Work Order ID 92856

Item Name: Crosstube Turning Detail

DART AEROSPACE LTD	Work Order:	92856
Description: Crosstube Assembly (205/212/412 High Fwd)	Part Number:	D212-664-141
Inspection Dwg: D212-664-141 Rev: D		Page 1 of 2

DRAWING NO. D212-664-141	TITLE XTUBE ASSY (205/212/412 HI FWD)	REV. D	DART AEROSPACE LTD ENGINEERING ORDER		D.E.O. NO. D212-664-141-D-1	SHEET NO. SHEET 1 OF 2	SCALE NTS
DRAWN	CHECKED <i>UP</i>	MFG. APPR. <i>R</i>	APPROVED <i>MP</i>	DE APPR. <i>H</i>			
DATE 11.04.07	DATE 11.07.11	DATE 11.04.12	DATE 11/04/12	DATE 11.04.12

**D212-664-141/-141B
ASSEMBLY DETAIL**

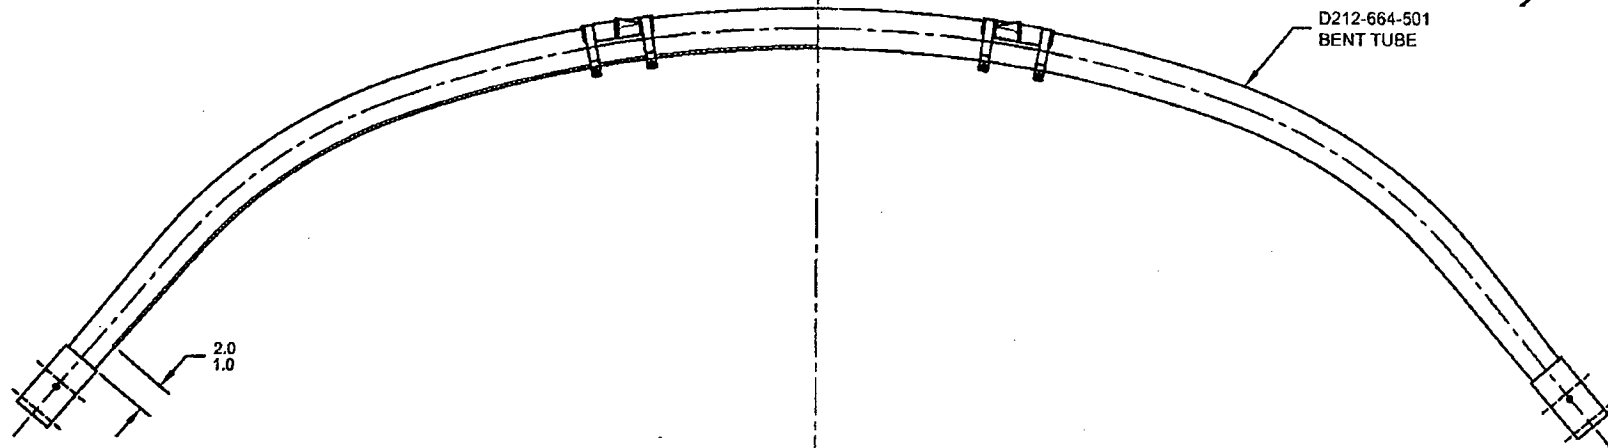
ADD AN INSPECTION WINDOW TO UNDERSIDE OF CROSSTUBE.

NOTES 2 OF SHEET 1 IS AMENDED AS FOLLOWS:

- 2) FINISH: CHEMICAL CONVERSION COAT PER DART QSI 005 4.1
PRIME INSIDE AND OUTSIDE PER DART QSI 005 4.2
MASK UNDERSIDE OF CROSSTUBE AS SHOWN (HATCHED AREA) AND
PAINT OUTSIDE PER DART QSI 005 4.2
REMOVE MASKING AND APPLY CLEAR COAT

MASK AREA PRIOR TO PAINTING.
REMOVE MASKING AFTER PAINT
AND APPLY CLEAR COAT
